NOTICE OF PROPOSED CHANGE IN PROPERTY

Petition: x1340

Sketches received with the Notice indicate "MULTIPLE ENCROACHMENTS IN THE BLOCK BOUND BY WOODWARD AVE., ELIZABETH ST., PARK AVE., AND THE ALLEY FORMELY KNOW AS COLUMBIA ST."

- MULTIPLE ENCROACHMENTS

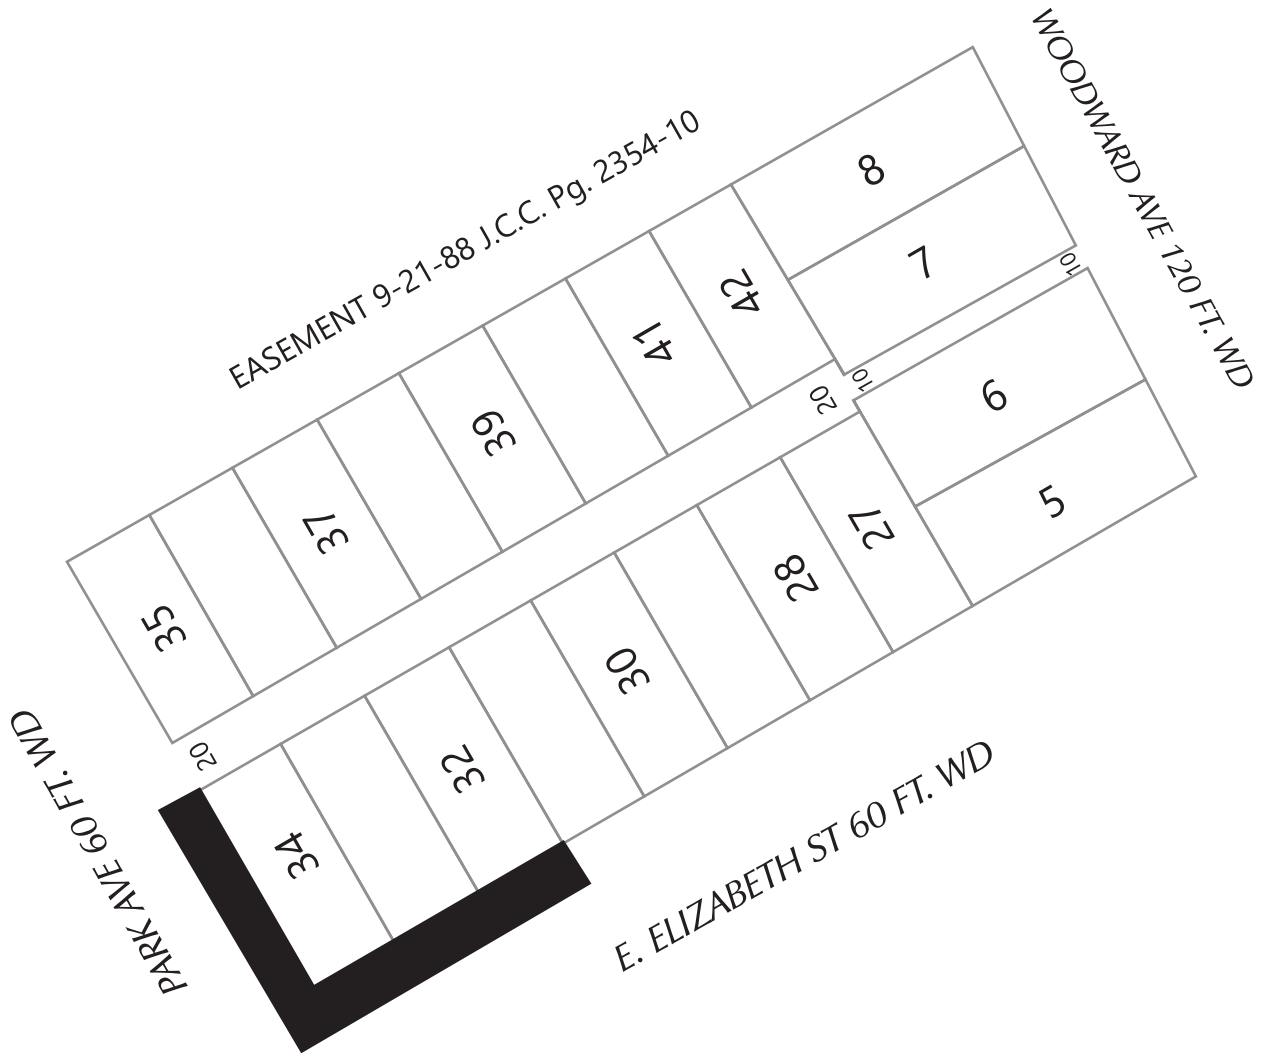
However the documentation provided indicates that only encroachments into Park Avenue, from Elizabeth Street to the alley south of Columbia, and Elizabeth Street, from Park Street to the east property line of the building, have been requested. DTE has no objections to the encroachments within these boundaries based on the above information.

DTE maintains underground infrastructure in the alley north of Park/alley south of Columbia and objects to any encroachment in this area.
